Comments on applications for referral under the COVID-19 Recovery (Fast-track Consenting) Act 2020

Project name	Teal Park Stage 1
General comment – potential benefits	Will add additional housing supply and choice as well as industrial activities, which will generate employment opportunities, in the Auckland region. A local park is also added to the community.
General comment – significant issues	<p>It is considered that the proposal could potentially contribute to and exacerbate misalignment between the timing of transport infrastructure and the urbanisation of greenfield areas. This compromises the ability to sequence and deliver future urban development in a sustainable, coordinated, and cost-efficient way. Further details on this are contained in Auckland Transport's comments below.</p> <p>The application is inconsistent with the Auckland Unitary Plan and with the land use pattern identified in the Whenuapai Structure Plan 2016 (see the Plans and Places team's comments below).</p> <p>There is a risk that the vested assets Council may inherit are not consistent with the Council's standards or the community needs (see the Parks team's and the local board's comments).</p> <p>There

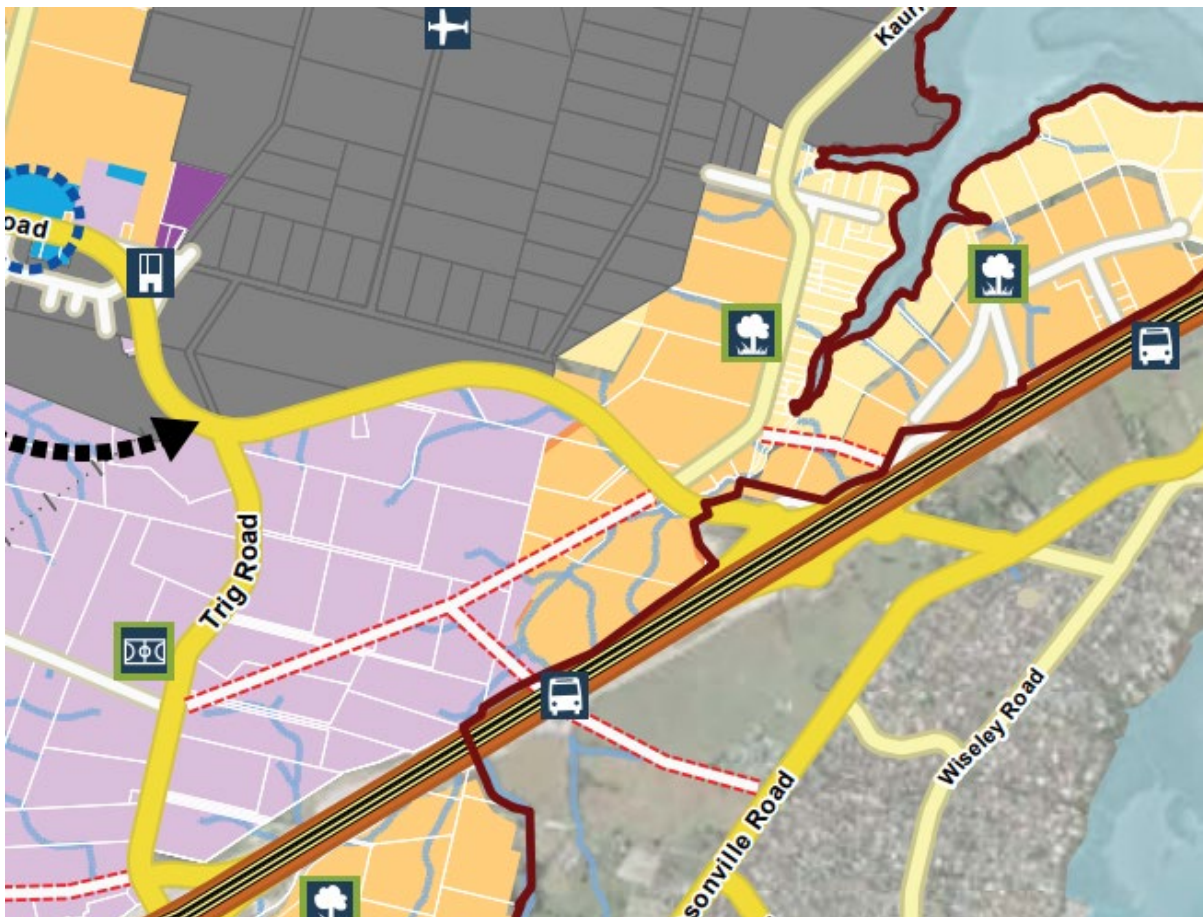
In my view the scale and nature of this proposal is contrary to the Future Urban Zone objectives and policies and could compromise the future urban development of the adjoining land in particular. Reverse sensitivity effects could also arise for the proposed industrial uses from future adjoining residential land uses.

The proposed subdivision and subsequent development is however, unlikely to compromise the future development of an interconnected local roading network as no “proposed roads” are identified on the Structure Plan in this vicinity.

The scale and character of the proposal also do not maintain and complement the current rural character and amenity.
